DRI REGIONAL REVIEW FINDING

RE: Development of Regional Impact (DRI) Review

Name of Proposal: Westwood DRI 4057

2023 WESTWOOD DRI

DRI SITE PLAN

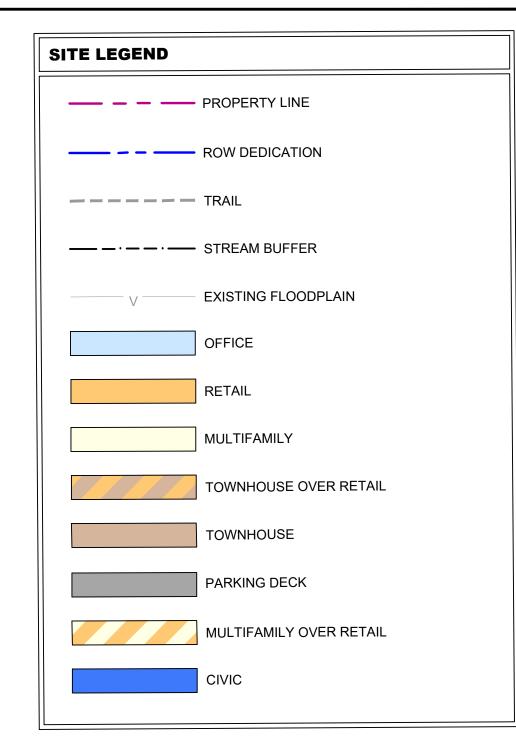
A high degree of walkability is key to reducing the project's traffic impact. While sidewalks are proposed along all internal roadways, additional pedestrian and bicycle measures are recommended, including provision of a multi-use path along the spine road connecting the village center to the lower density areas to the west.

Some stream buffers appear to not be properly labeled and some project elements fall within buffer areas shown. All stream buffers need to be properly labeled and stream buffer intrusions may require variances.

The USGS coverage for the site shows no blue-line streams. The site plan shows five unnamed streams or stream segments throughout the property. All but one end in wetland areas and do not extend to the river. No 35-foot buffer is required on these streams in the Corridor portion of the property because they are not blue-lines. All show unidentified buffers that appear to be the City's 50-foot stream buffer and additional 25-foot impervious setback, as well as the State 25-foot State Erosion and Sedimentation Control buffer. These should be identified on the plans. One road stream crossing is visible on the northernmost stream, and one road paralleling the stream appears to be within the 75-foot setback of that stream. A portion of a multi-family building appears to intrude on the 75-foot buffer of the stream at the center of the property. Several proposed lots also extend into the setback and buffer. Except for the stream crossing, all these intrusions may require variances. Any unmapped streams may be subject to the County Stream Buffer Ordinance and the State 25-foot State Erosion and Sedimentation Control buffer. Any unmapped State waters identified on the property will also be subject to the State 25-foot Sediment and Erosion Control buffer. The 50 undisturbed buffer and 150-foot impervious surface setback required under the MRPA/Chattahoochee Corridor Plan will need to be shown in the formal Corridor review.

The USGS coverage for the project area shows no blue-line streams on the property. The submitted site plan shows five unnamed streams or stream segments throughout the property. All but one end in wetland areas and do not extend to the river. No 35-foot buffer is required on these streams in the Corridor portion of the property because they are not blue-lines. All show unidentified buffers that appear to be the City's 50-foot stream buffer and additional 25-foot impervious setback, as well as the State 25-foot State Erosion and Sedimentation Control buffer. These should be identified on the plans. One road stream crossing is visible on the northernmost stream, and one road paralleling the stream appears to be within the 75-foot setback of that stream. A portion of a multi-family building appears to intrude on the 75-foot buffer of the stream at the center of the property. Several proposed lots also extend into the setback and buffer. Except for the stream crossing, all these intrusions may require variances. Any unmapped streams may be subject to the County Stream Buffer Ordinance and the State 25-foot State Erosion and Sedimentation Control buffer. Any unmapped State waters identified on the property will also be subject to the State 25-foot Sediment and Erosion Control buffer. The 50 undisturbed buffer and 150-foot impervious surface setback required under the Metropolitan River Protection Act and Chattahoochee Corridor Plan will need to be shown in the formal Corridor review.
